AGENDA
CHASKA PLANNING COMMISSION
CHASKA CITY HALL - COUNCIL CHAMBERS & ZOOM
Wednesday, April 9, 2025
7:00 PM

REQUEST FOR ACTION CHASKA PLANNING COMMISSION 4/9/2025

Subject: Beckman Coulter – 316 Lake Hazeltine Drive – Preliminary Site & Building Plan

To: Planning Commission
From: Alex Mollenkamp, Assistant City Engineer
Date: April 3, 2025
Subject: Beckman Coulter Preliminary Site & Building Plan – Engineer’s Memo

C400

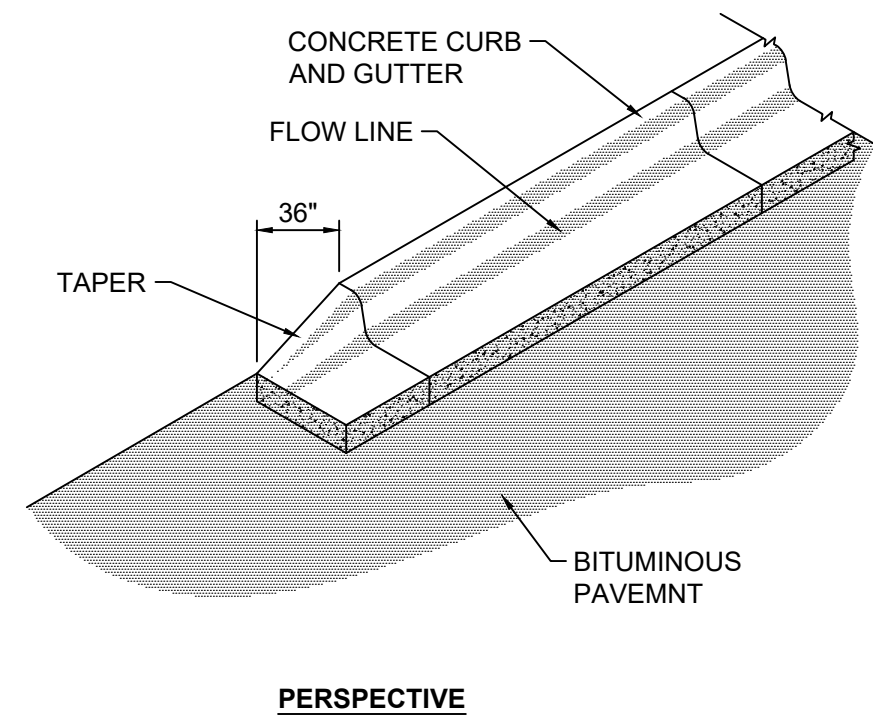
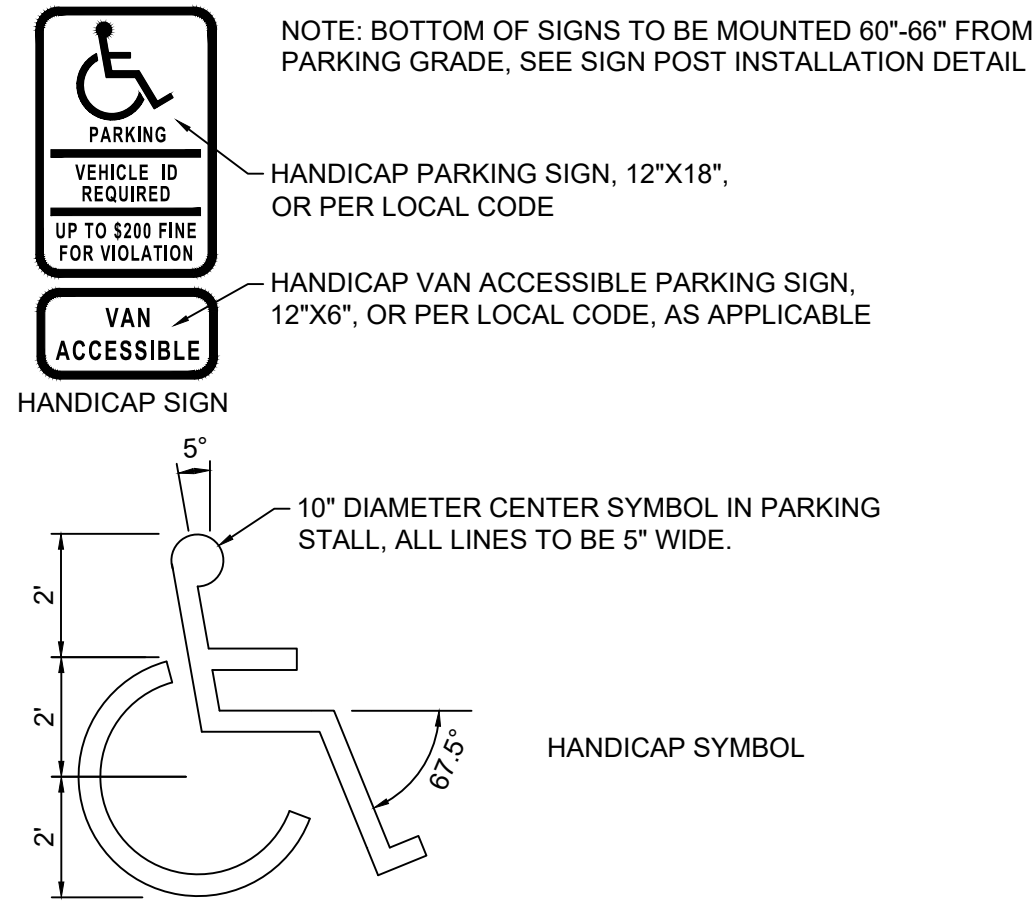
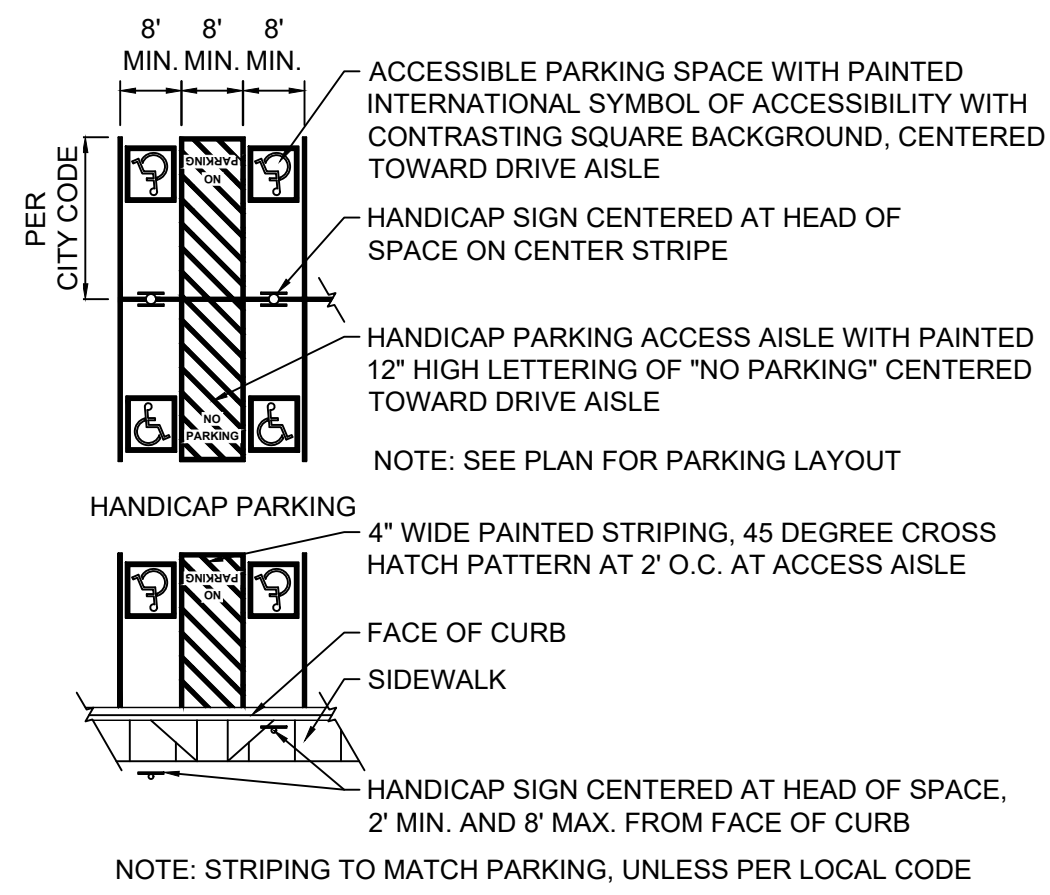
- 4. Fire truck turning exhibit, including:
 - a. Use city's fire truck template (attached)
The City's fire truck template was used in the updated fire truck turning exhibit. Minor modifications to the drive aisle and parking stall width are reflected on sheet C400 to accommodate the City's truck template.

L200

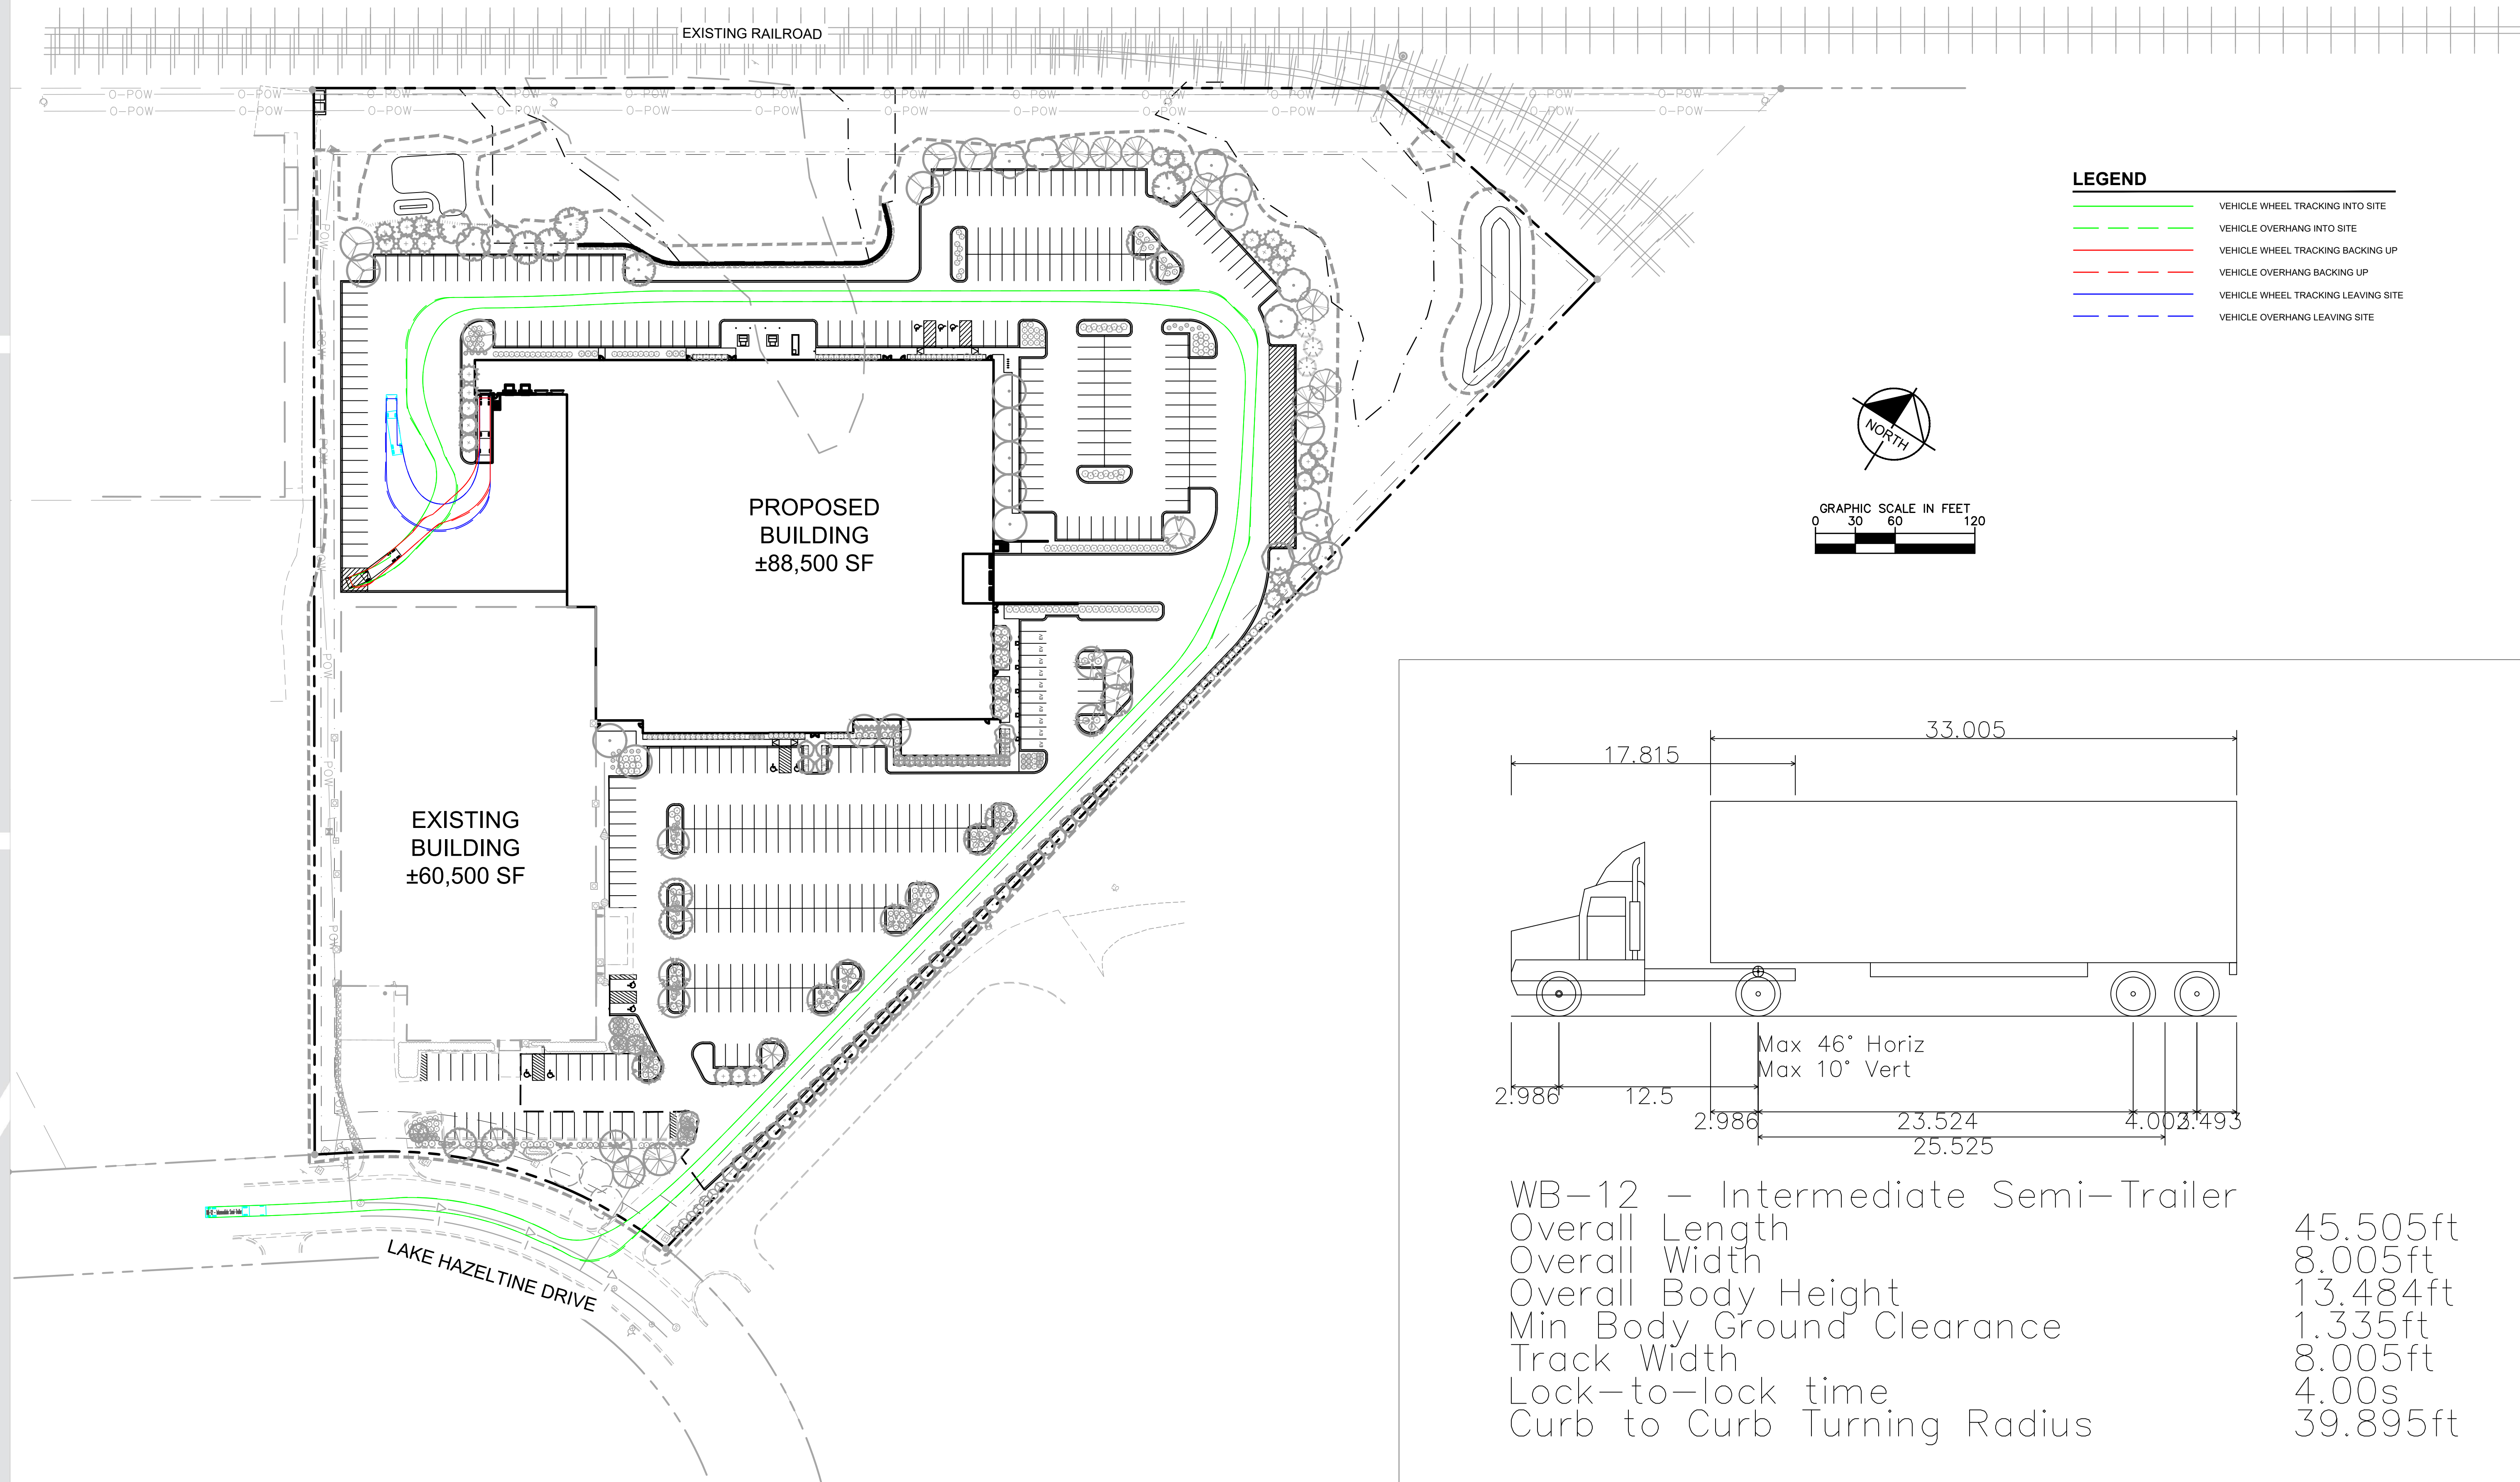
- 3. Truck turning exhibit, including:
 - a. Overlay of landscape plan on all exhibits – there are concerns with the proposed turning movements impacting the curbing and landscaping along the east edge of property.
The landscape plan was overlaid on all truck turning exhibits. Truck movements show the proposed plantings will not interfere with operations. Tree species that grow up with limited canopy spread (Prairie Sentinel Hackberry and Kindred Spirit Oak) were selected adjacent to the main truck traffic areas. See sheet L200 for additional information.
